**BUILDING AND STANDARDS COMMISSION
STAFF REPORT**

June 21, 2021

Case # 2406 – 120 South Main Street

LEGAL DESCRIPTION: City Of Bryan Townsite, Block 256, Lot 1 (40' of) & 11' of W 27th St, "La Salle Hotel" & Associated BPP

Fire rated steel windows on North façade.

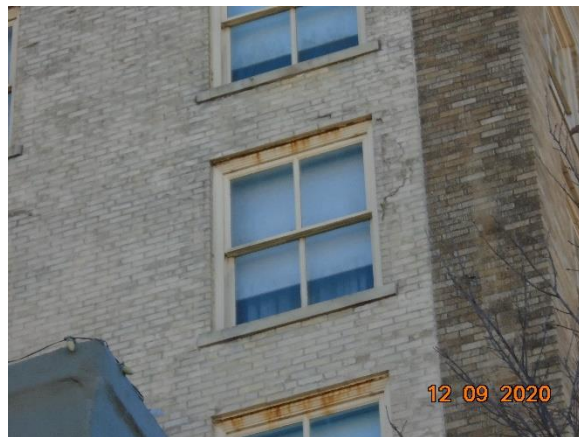
Steel lintels are rusting and possibly causing masonry damage.

- all repairs to the North facing fire rated windows and surrounding elements, including, but not limited to replacing broken glass, repaint, repair rust on windows, repair or replace rusty lintels, repair and/or repoint masonry around windows where damaged, must be completed by November 1, 2021;**

Interior guest room window with damage

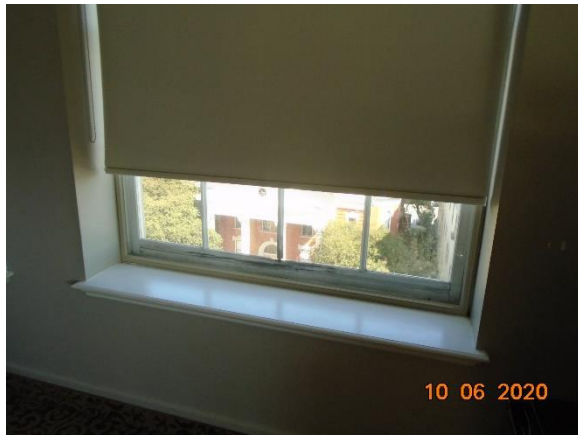
Rotten/damaged sash

Window mullions loose
